United States Nuclear Regulatory Commission

INDIANA MICHIGAN POWER COMPANY
 Donald C. Cook Nuclear Plant
 1 Cook Place
 Bridgman, MI 49106
 616-466-2835
SHIPPING MEMORANDUM

Quantity	Item Description	Box Size	Weight
1	Radiological Surveys for Controlling Release of Solid Materials		6.15
			6.15
Total			Total

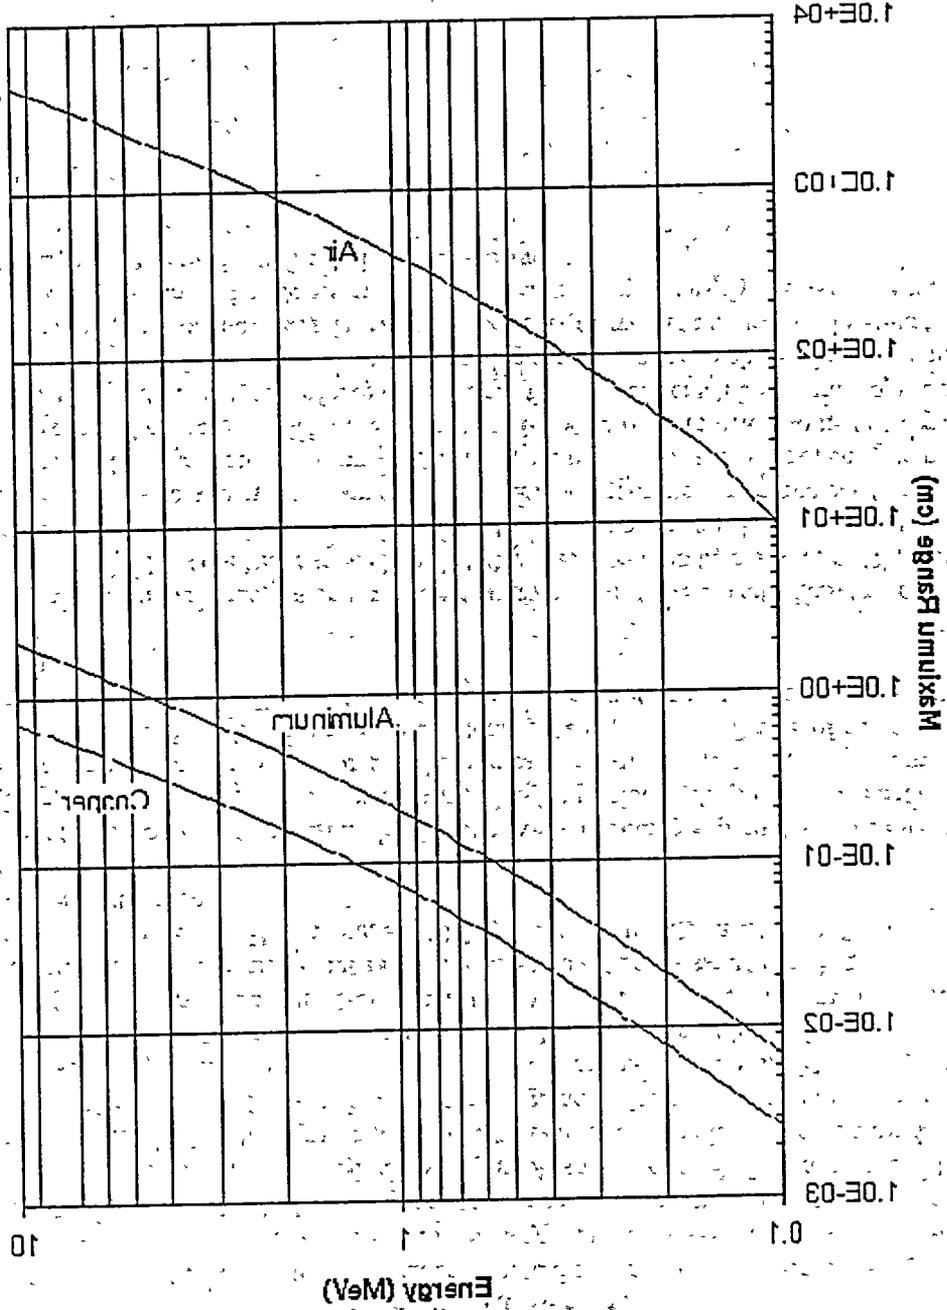
Nice MacKewards graph

Nice backwards graph
